IAE Propulsion System NON-MODIFICATION SERVICE BULLETIN

Subject: Transmittal of Revision 2 to Service Bulletin Number V2500-NAC-71-0208

NACELLE – POWERPLANT – SEAL, PYLON APRON, FORWARD UPPER AND LOWER –
REPLACEMENT OF

V2500-NAC-71-0208

Install the Upper and Lower Forward Pylon Aprons
Figure 2

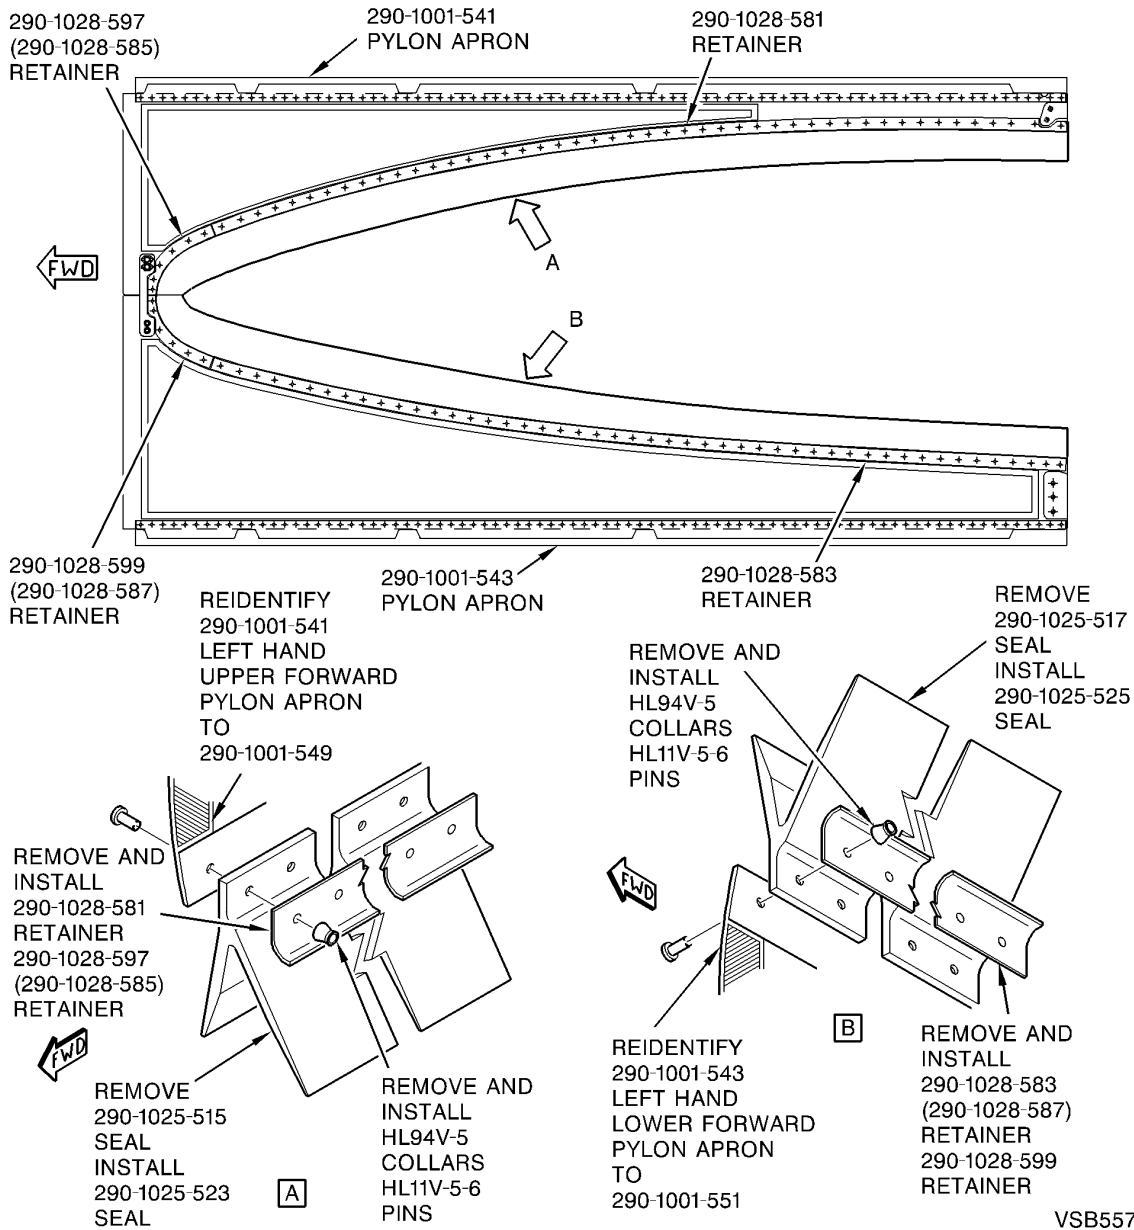
CAUTION: MAKE SURE THE SEALS ARE SPREAD AGAINST THE PYLON. MAKE SURE THE LOWER SEAL IS OVER THE UPPER SEAL WHERE THE SEALS COME TOGETHER AT THE FORWARD END OF THE PYLON. IF YOU DO NOT DO THIS, THE SEALS CAN GET DAMAGED AND ALLOW TOO MUCH AIR INTO THE FAN COWLS.

- (1) Install the upper and lower forward pylon aprons. Refer to the MD-90 Aircraft Maintenance Manual, Chapter 71-14-01, page block 401. Make sure the seals are spread against the pylon. Make sure the seals of the lower pylon aprons are over the seals of the upper aprons where they come together at the forward end of the pylon. Refer to Figure 2.

Modify the Left Forward Pylon Aprons
Figure 1 (Sheet 1)

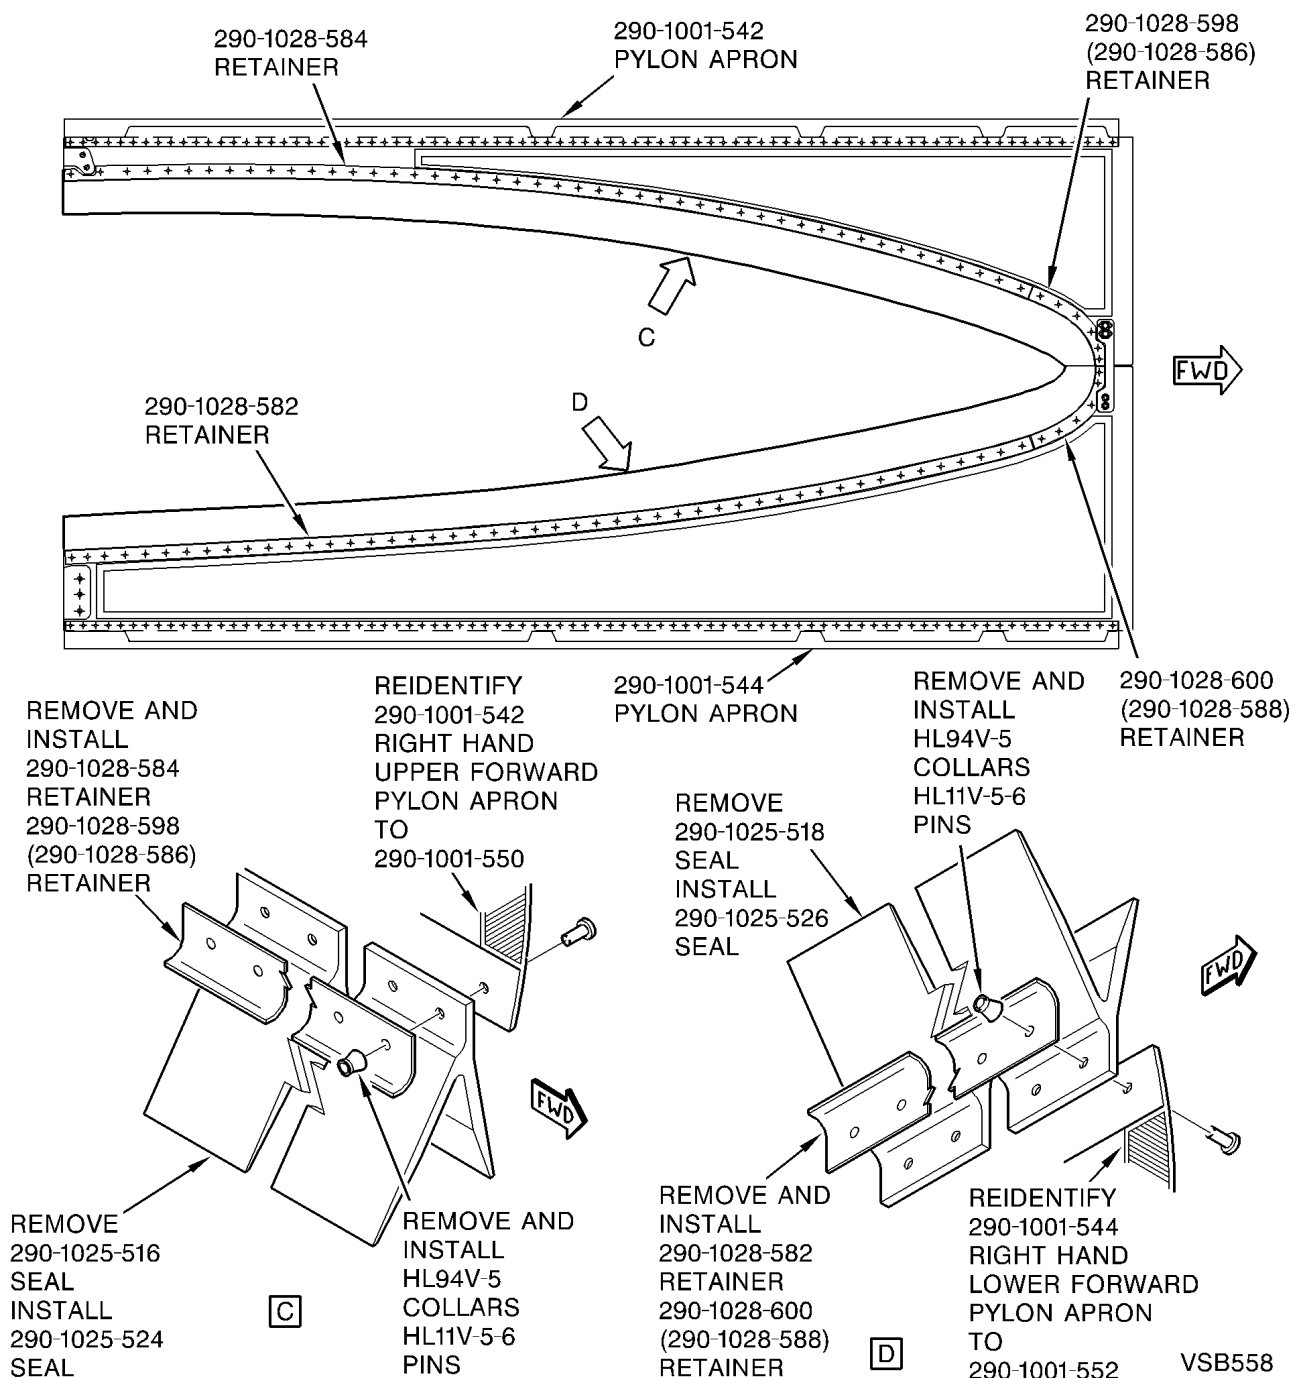
(1) To correct a typographical error in Figure 1 (Sheets 1 and 2).

- (1) Remove the collars and pins, the retainers and the seals from the 290-1001-541 and 290-1001-542 pylon aprons. Keep the retainers. Discard the seals and fasteners. Refer to Figure 1 (Details A and C).
- (2) Put the 290-1025-523 and 290-1025-524 seals into position and back drill the fastener holes in the seals. Refer to Figure 1 (Details A and C).

- (3) Mix the thinner (CoMat 07-116), catalyst (CoMat 07-139), and epoxy primer (CoMat 07-140). Refer to the manufacturer's instructions.
- (4) Install the 290-1025-523 seal, 290-1028-581 retainer, and 290-1028-597 (or 290-1028-585) retainer on the 290-1001-541 pylon apron with 53 HL11V-5-6 pins and HL94V-5 collars. Wet install the fasteners with the primer mix. Refer to Figure 1 (Details A and C).

Modify the Right Forward Pylon Aprons
Figure 1 (Sheet 2)

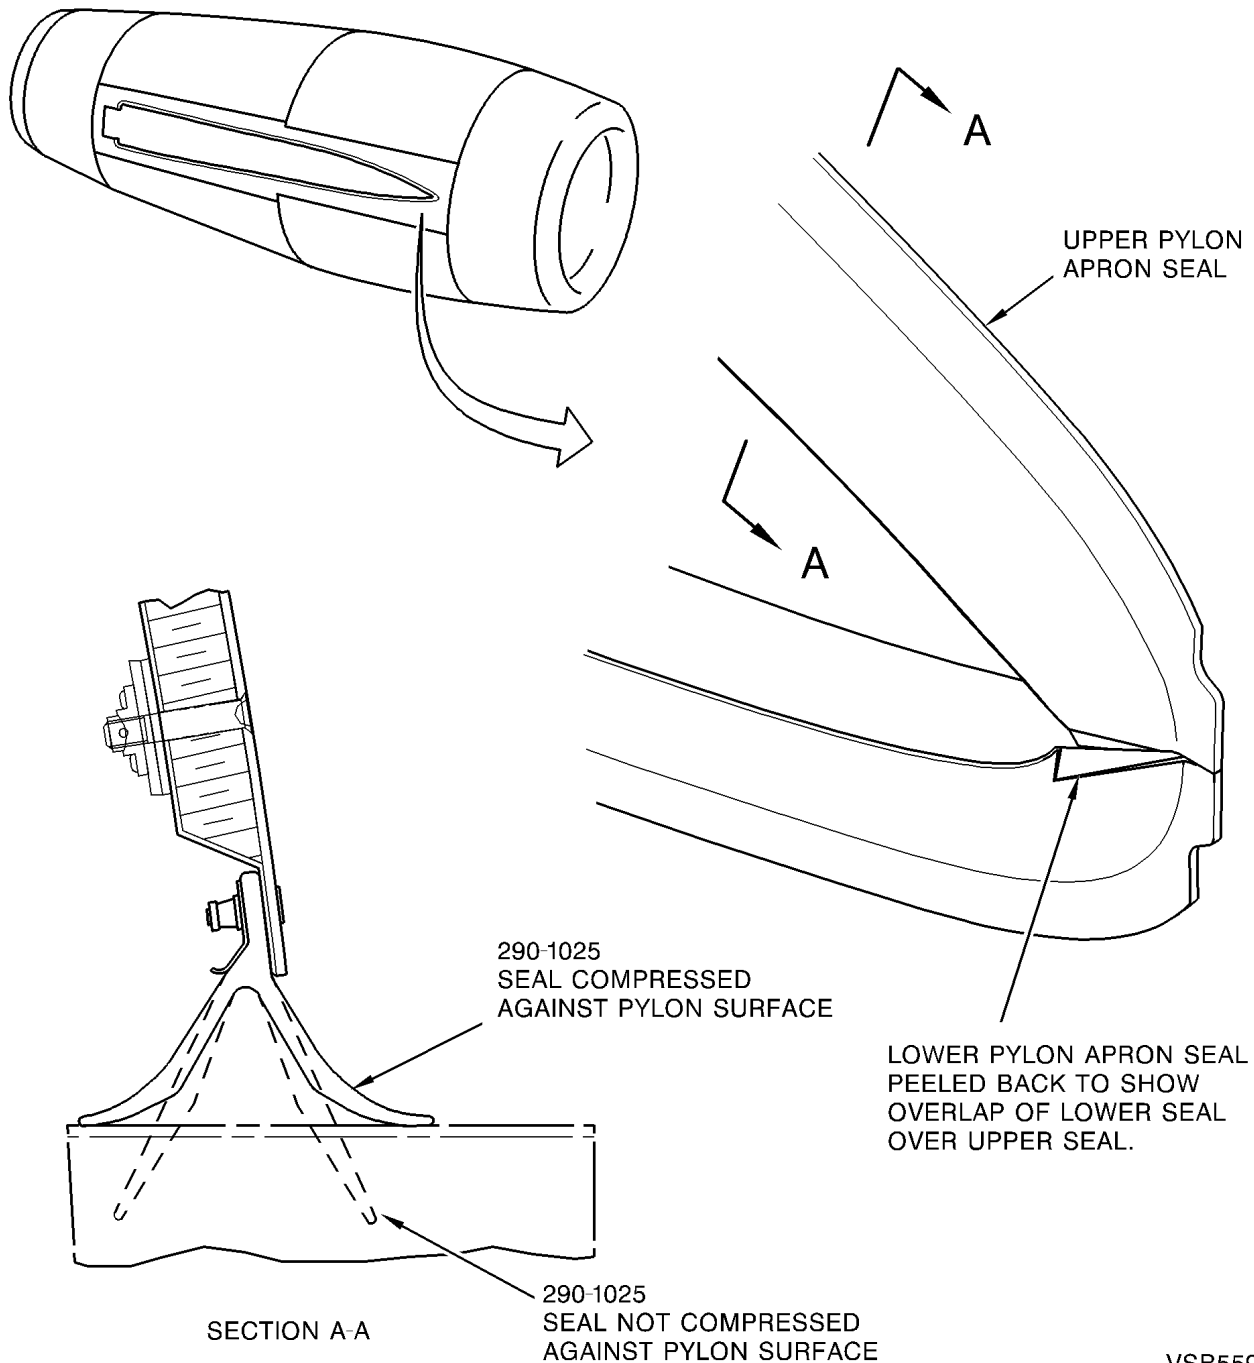
- (5) Install the 290-1025-524 seal, 290-1028-584 retainer, and 290-1028-598 (or 290-1028-586) retainer on the 290-1001-542 pylon apron with 53 HL11V-5-6 pins and HL94V-5 collars. Wet install the fasteners with the primer mix. Refer to Figure 1 (Details A and C).
